## LINCOLN CITY/LANCASTER COUNTY PLANNING STAFF REPORT

**P.A.S.:** Change of Zone #3369  
Special Permit #1978

**DATE:** June 11, 2002

**PROPOSAL:** A change of zone from AG Agriculture to R-4 Residential with a one-lot Community Unit Plan (CUP) for 120 multi-family units and clubhouse.

LANDSCAPE PLAN  
STONE RIDGE APARTMENTS

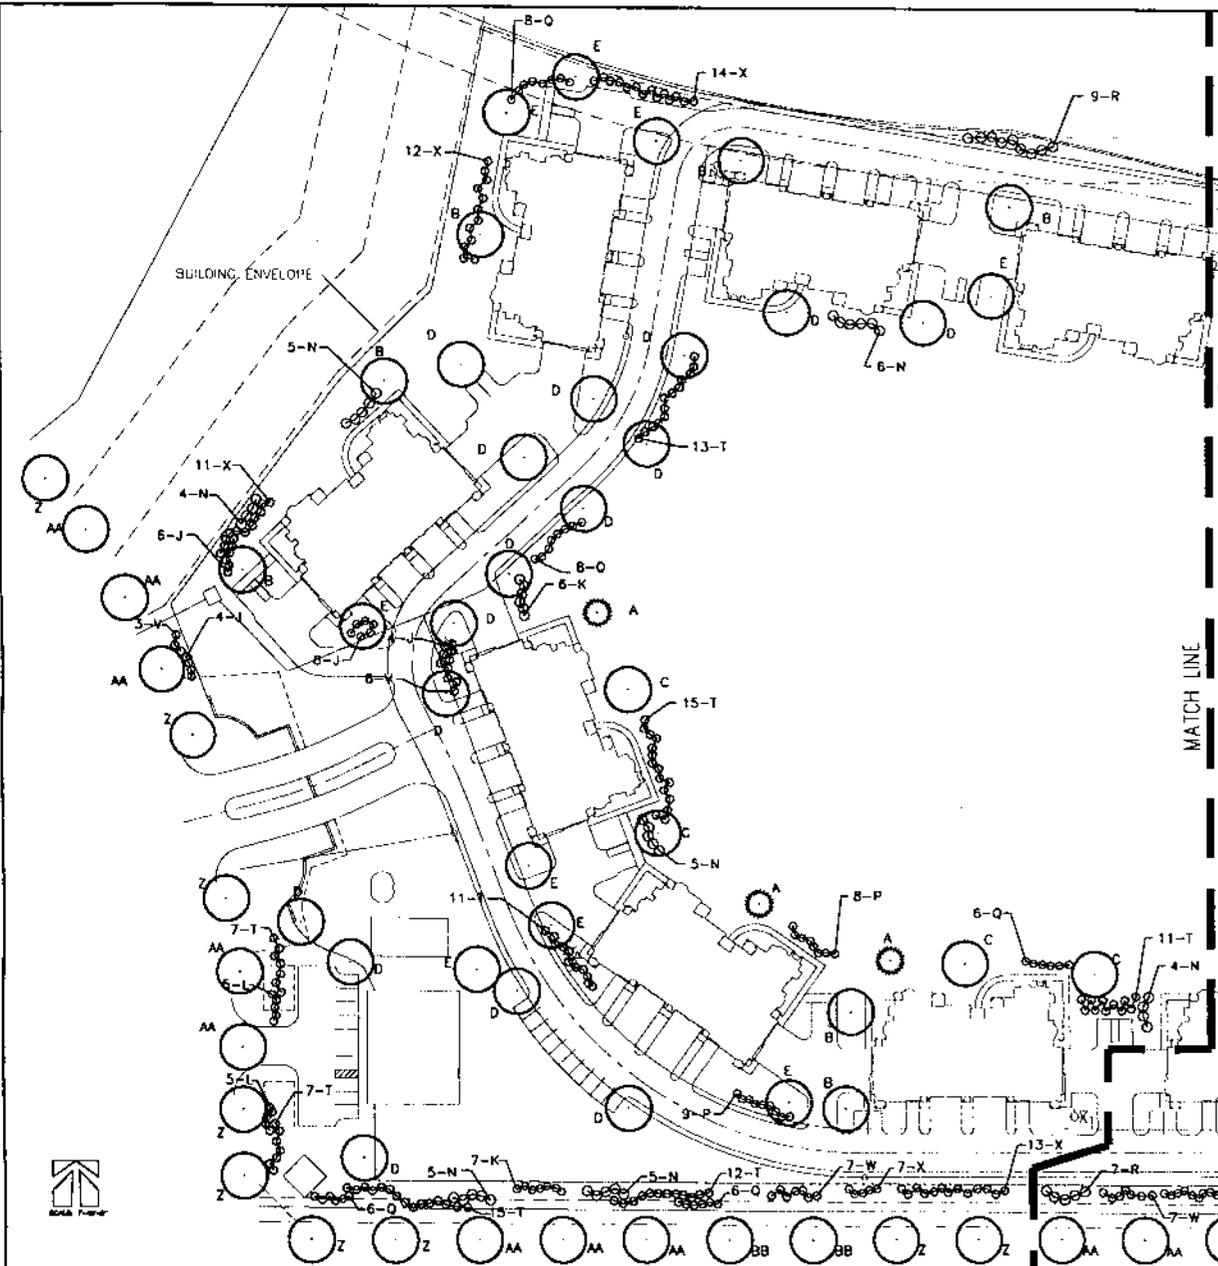
6. The two sign envelopes shown between the unlabeled building and Hollynn Lane are not allowed by the zoning ordinance and must be removed. Additionally, all sign envelopes must be indicated on the landscape plan as required by the Zoning Ordinance.

1.1.3 Delete the two sign envelopes shown between the clubhouse and Hollynn Lane. The landscape plan must also be revised to show all remaining sign envelopes.
